Access Compliance Report Public Rights-of-Way (Curb Ramps)

Main Street: SAUVIGNON_DR		Cross Street: CHARDONNAY_DR		Location:	S
ADA ID: RPAT211103105959	Ramp Type: Type 4 - Parallel	Initial Pass/Fail: Fail	Overall Compliance: No	Severity Score:	15
Codes/Mitigation Info/Possible Solution			Field Measurements/Component Compliance

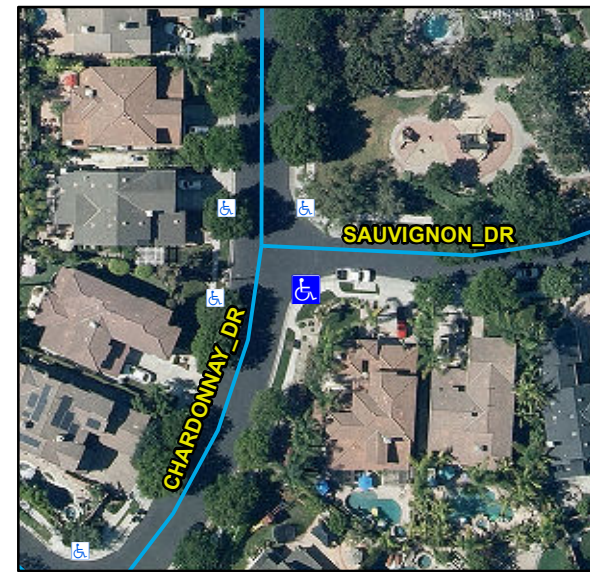
Compliance	Description	Data	Compliance	Description	Data
N/A	Ramp Length LT (in)	105	N/A	Ramp Length RT (in)	100
Yes	Ramp Width LT (in)	54	Yes	Ramp Width RT (in)	54
No	Ramp Run Slope LT (%)	8.5	Yes	Ramp Run Slope RT (%)	3.5
Yes	Ramp Cross Slope LT (%)	0.3	Yes	Ramp Cross Slope RT (%)	1.3
N/A	Landing Present	N/A	N/A	DWS Provided	N/A
N/A	Landing Length (in)	N/A	N/A	DWS Contrast	N/A
N/A	Landing Width (in)	N/A	N/A	DWS Length (in)	N/A
N/A	Landing Run Slope (%)	N/A	N/A	DWS Full Width	N/A
N/A	Landing Cross Slope (%)	N/A		DWS Offset Type	N/A
N/A	Landing Movement Obstructed?	N/A	N/A	DWS Offset Left (in)	N/A
	Landing Movement Type	N/A	N/A	DWS Offset Right (in)	N/A
N/A	Landing Shared	N/A			
N/A	Clear Space	Yes			
N/A	Clear Space To Crosswalk (in)	N/A			
N/A	Marked Crosswalk 1	No	N/A	Marked Crosswalk 2	No
	Crossing 1 Direction	NE		Crossing 2 Direction	NW
	Marked Crosswalk 1 Width (in)	N/A		Marked Crosswalk 2 Width (in)	N/A

Remove & Replace Curb Ramp With Two New Directional Ramps or Equivalent.
